Register Reference: SD22A/0372 AI

Development: Demolition of existing two storey detached dwelling house and outbuildings; Construct new purpose built three storey mixed used building with, a new physiotherapy practice, consisting of 5 consultation rooms, office space, staff areas as well as a rehab gym and studio area, all over two floors at ground and first floor levels; One bedroom apartment with own door access and dedicated private balcony area at the second floor level; 5 car parking spaces and secure bicycle parking for 6 bicycles all on site; Back lit signage to the front facade of the building; All associated site development works.

Location: Saint Claires Villa, Lucan Road, Lucan, Co. Dublin, K78 X0N1

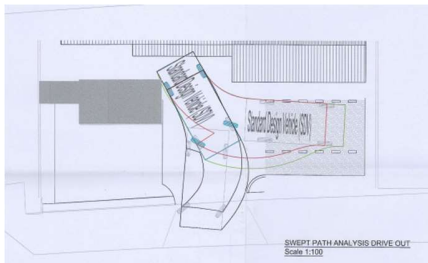
3. The applicant is requested to provide the following information to facilitate a complete assessment of the proposed development:
 - (i) A Construction & Demolition Waste Management Plan (C&DWMP), to include details of the number of loads, haulage routes, times of works, etc.
 - (ii) A site layout plan of not less than 1:100 scale, showing a swept path analysis drawing (i.e. AutoTRAK or similar) demonstrating
 - (a) how cars safely access/egress the proposed new parking spaces.
 - (b) that fire tenders and large refuse vehicles can access/egress the site.

Please see attached Auto Track Drawing prepared by ONCE engineers showing the safe movement of cars in and out of the site.

Roads Department Assessment:

AI has been assessed and requirements have been met.
